**RE: 16717 Chirco Drive – Cover Letter for Letter of Justification**

Applicant: Deepak Gupta  
Prepared by: Bay Area Project Pro  
To: Town of Los Gatos Planning Division

Date: July 2, 2025

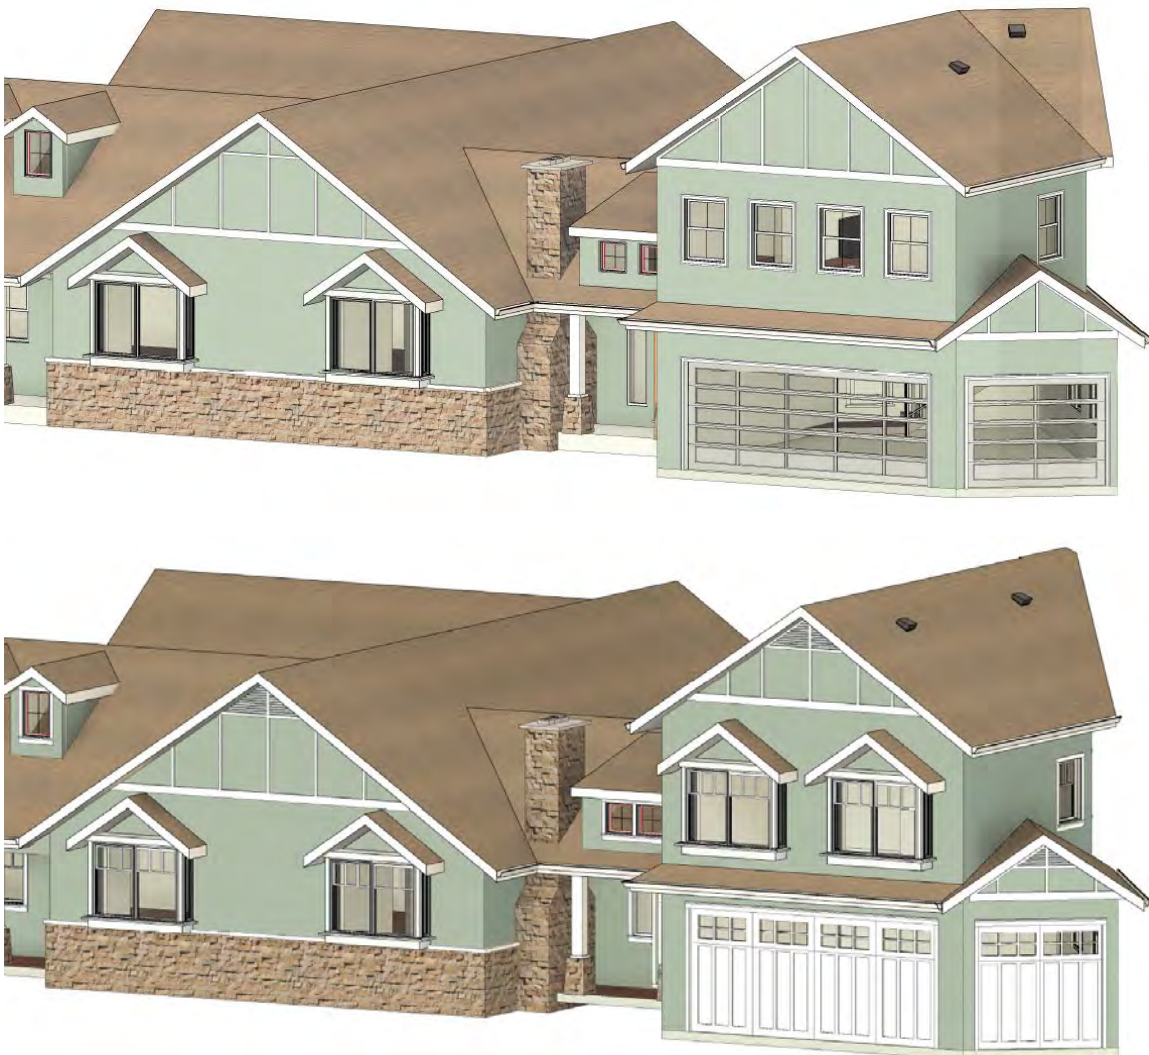
**Response to Item 11) Provide a Letter of Justification to address that the proposed second story addition may be the tallest in the immediate neighborhood. Town records for 15589 Benedict Lane are limited and without the height of the residence identified. However, this home appears to be two stories in the immediate neighborhood. Town records for 16736 Chirco Drive is another two-story home that is two-stories. Please discuss how the new addition will/will not result in the tallest and how the design addition is in keeping with the neighborhood.**

**Response:** This letter addresses the concern that the proposed second story addition may be the tallest structure in the immediate neighborhood. Town records for nearby properties are incomplete in some cases, and height data is not consistently available. To provide an accurate and objective assessment, **we conducted direct field laser guided measurements**. Each property was measured three times to minimize error; the average values are reported below.

- **16700 Chirco Drive** (across the street, diagonally left): **26 feet**
- **16736 Chirco Drive** (across the street, diagonally right): **27 feet**
- **15589 Benedict Lane** (adjacent): **25 feet**
- **16763 Chirco Drive** (two homes away): **30 feet**
- To validate the accuracy of our method, we also measured our current residence at **16717 Chirco Drive**, which yielded a height of **20 feet**. The known actual height of our home is **19' 10 1/4"**, confirming a measurement accuracy **greater than 99% with our measurement device**.

In summary, the proposed second story addition has a maximum height of **26' 9"**, which places it squarely in the middle of the range of existing two-story homes in the immediate neighborhood and well under the town limit of 30 feet. In fact, **it is the median value** in this sample of two-story properties based on our measurements. While we believe the current height is both reasonable and contextually appropriate, we are willing to work collaboratively to find a solution that meets both design goals and community expectations.

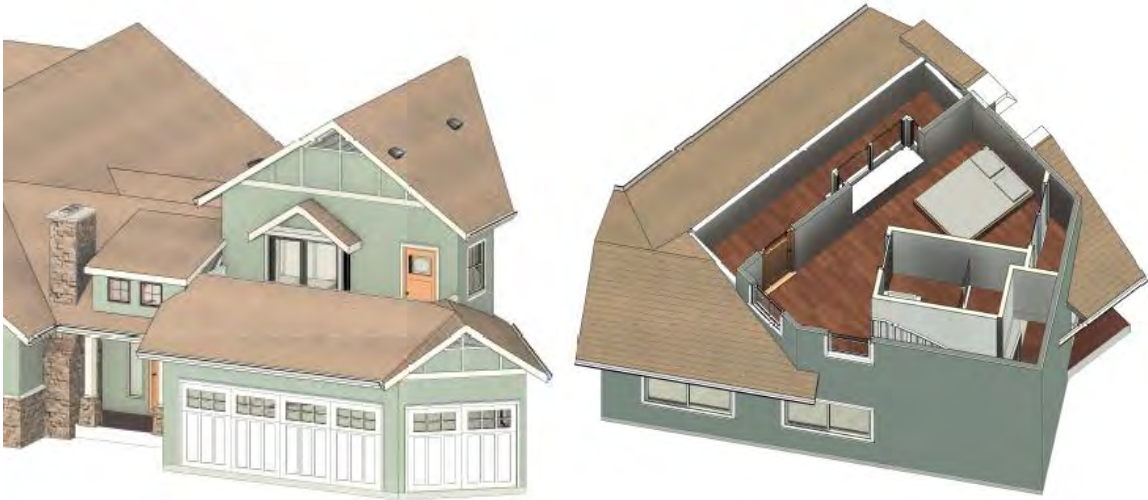
**Response:** We would like to clarify that there was an **error on the originally submitted plans** that showed only an exterior door accessing the stairwell. This was not intentional and does not reflect the intended design. The correct configuration (see plans) places the doorway to the stairwell directly in the existing interior entry foyer, ensuring a cohesive and practical connection between the second story bedroom space and the main home.

Our revised layout is corrected specifically to support a seamless internal doorway that maintains the usability, privacy, and comfort of the interior space of the home.

Moreover, the stair placement allows us to preserve the extended length of the third garage stall, which is essential for accommodating our full-size vehicles (Chevrolet Suburban and Ford Expedition EL). Due to the layout of the existing home and the location of the foyer, the staircase can only be reasonably situated at the rear of the foyer and garage. As a direct result, the second-story square footage must also be concentrated toward the back of the proposed addition to maintain proper vertical alignment and functional interior flow. This configuration reflects both practical necessity and thoughtful integration with the existing floor plan.

As a result, the proposed design now incorporates an **“open to below” space** on the second story, which brings natural light into the garage, enhances architectural cohesion along the front façade, and provides a fully integrated roof structure over the garage to minimize the risk of water intrusion.

Rejected Design #2:

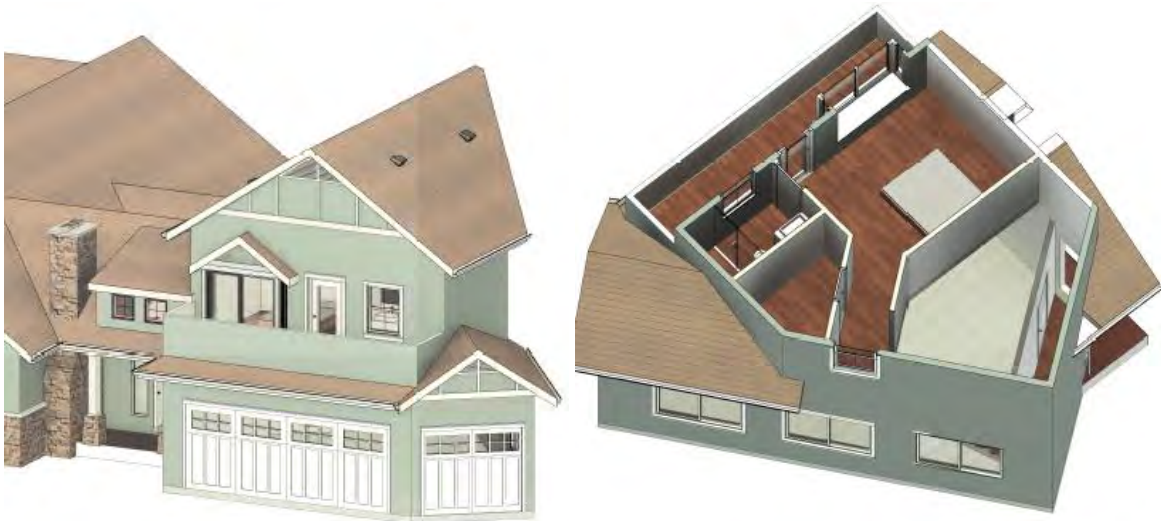
We carefully considered alternative options, including a **flat roof or balcony** over the front garage volume. However, these proved to be **less compatible with the architectural language** of the existing home, introduced **greater potential for [inevitable] long-term water intrusion**, and **visually disrupted the continuity** of the second story. Designs incorporating a gabled roof above the garage or a pony-walled balcony tend to **obscure key second-story architectural elements** and lead to **disjointed visual lines** between the garage level and the upper floor as well as with the original residence.

Additionally, we anticipate little to no regular use of a front-facing balcony at that location, raising the concern that it could become a visual eyesore or attract clutter over time, which would detract from the overall aesthetic and streetscape. A front-facing

balcony is also fraught with safety concerns, especially with young children in the house. Given the tight dimensional constraints of the site and required setbacks, this configuration represents a careful balance of architectural alignment, functionality, and spatial efficiency.
